City of Santa Fe, New Mexico

memo

FROM: Paul A. Duran, Senior Planner, Historic Preservation Division

2025-010494-HDRB, 206 McKenzie St., Downtown and Eastside Historic District, Contributing, Bradyn Furry, agent for Mindy Hale and FC3 Ltd. Co., owner, requests approval to replace all the doors and windows which requires an exception to 14-5.2(D)(1)(a) for the removal of historic material; construct a new detached steel carport to a height of 8'-8" with roof-mounted solar units within the existing auto court which requires an exception to 14-5.2(D)(E) Downtown and Eastside Design Standards; an increase in height by 3'-3" of a previously approved parapet on the McKenzie St. façade which requires an exception to 14-5.2(D)(2)(c) additions are not permitted unless set back 10' from primary facade, and install roof top HVAC units, and a new pedestrian gate on the McKenzie St. adjacent to the vehicle entrance.

Figure 1. Primary Facade Diagram,

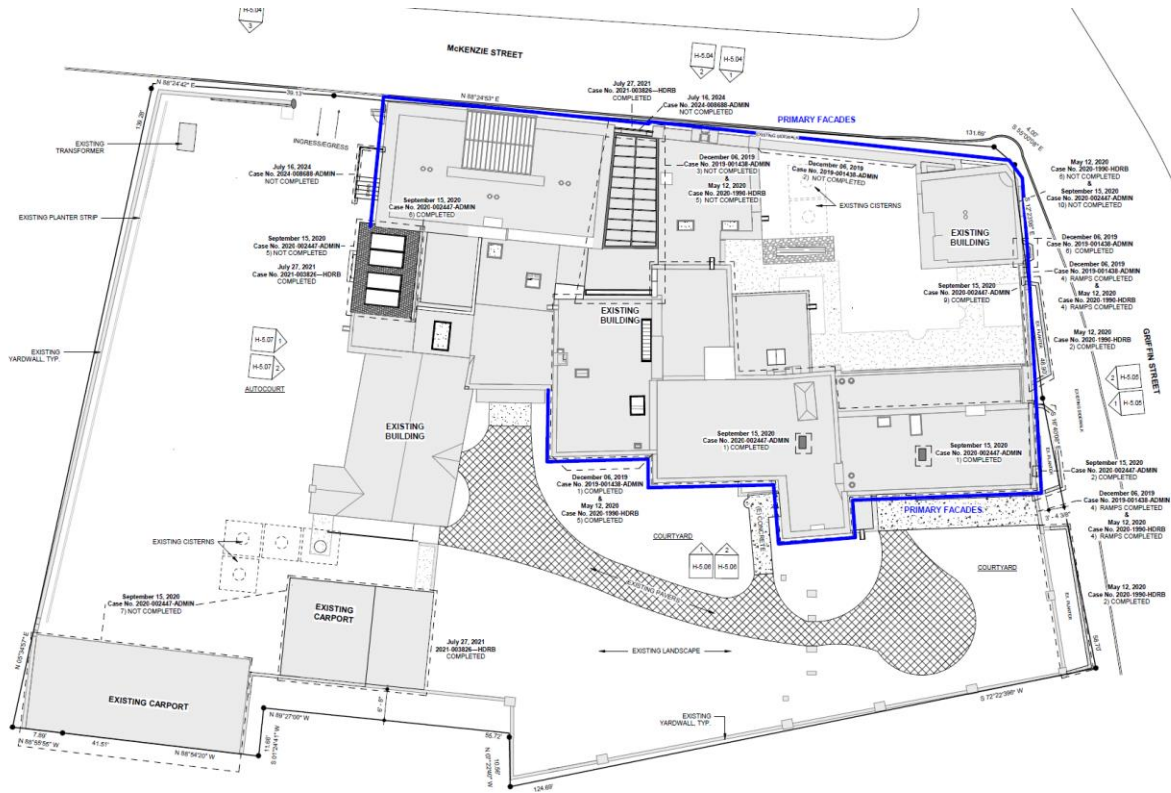
The mixed-use commercial and multi-family complex at 206 McKenzie Street is listed as contributing to the Downtown and Eastside Historic District with the north, east, and partial southern and western facades designated as primary. The original structure has been identified in the 2005 Historic Cultural Properties Inventory (HCPI) survey form to have been constructed pre-1766 to 1846 with several changes from the 1930s and 1940s into the present. The unique eclectic nature of the structure and location on the Grant Avenue and McKenzie Street streetscape has made this structure a stand-alone complex unmirrored by anything seen in the Downtown and Eastside Historic District.

Figure 2. Proposed Site Plan.

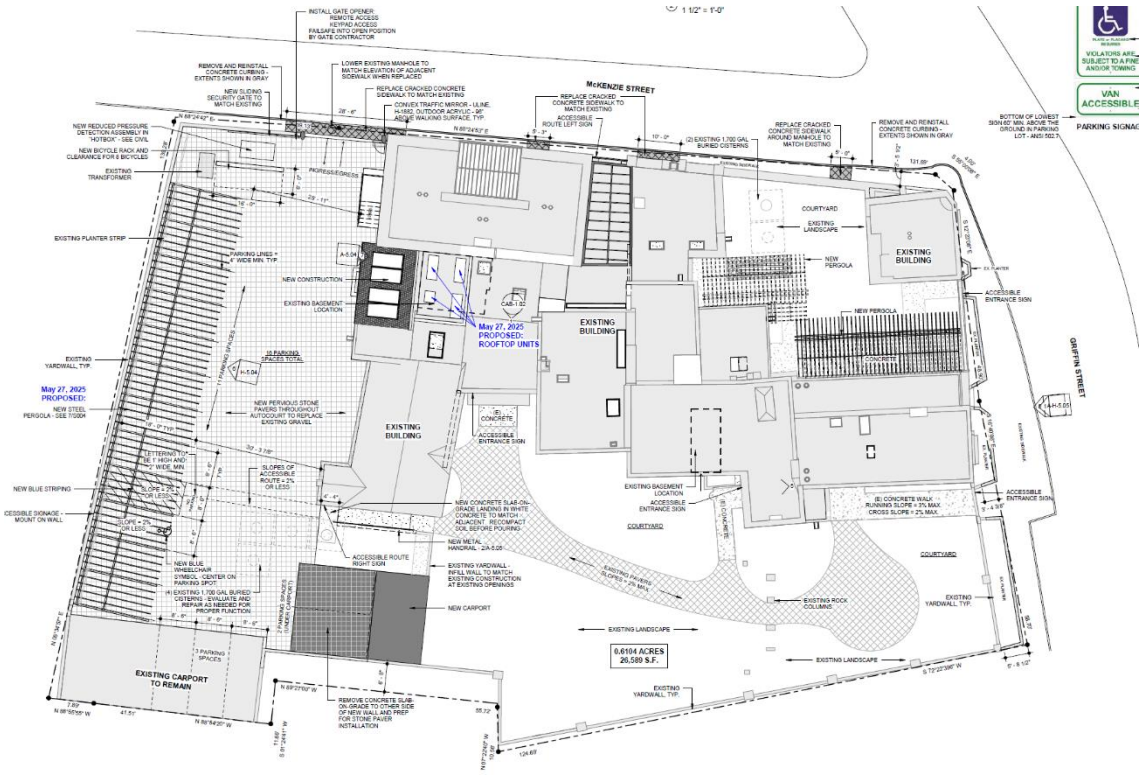
- 1) Replace all the doors and windows for which an exception is requested to 14-5.2(D)(1)(a) for the removal of historic material.
- 2) Construct a new steel carport within the existing autocourt for which an exception is requested to 14-5.2(E) to permit the use of metal for the structure in the Downtown & Eastside Historic District.
- 3) Change the overall height by 3'-3" from 14'-0 1/2" to 17'-3" high from a previously approved parapet on the McKenzie St for which an exception is requested to 14-5.2(D)(2)(c) [state the reason].
- 4) Roof mounted HVAC units.
- 5) Construct a new pedestrian gate on the McKenzie St. façade.
- 6) Re-stucco the exterior of the structure with a new one to match the existing.
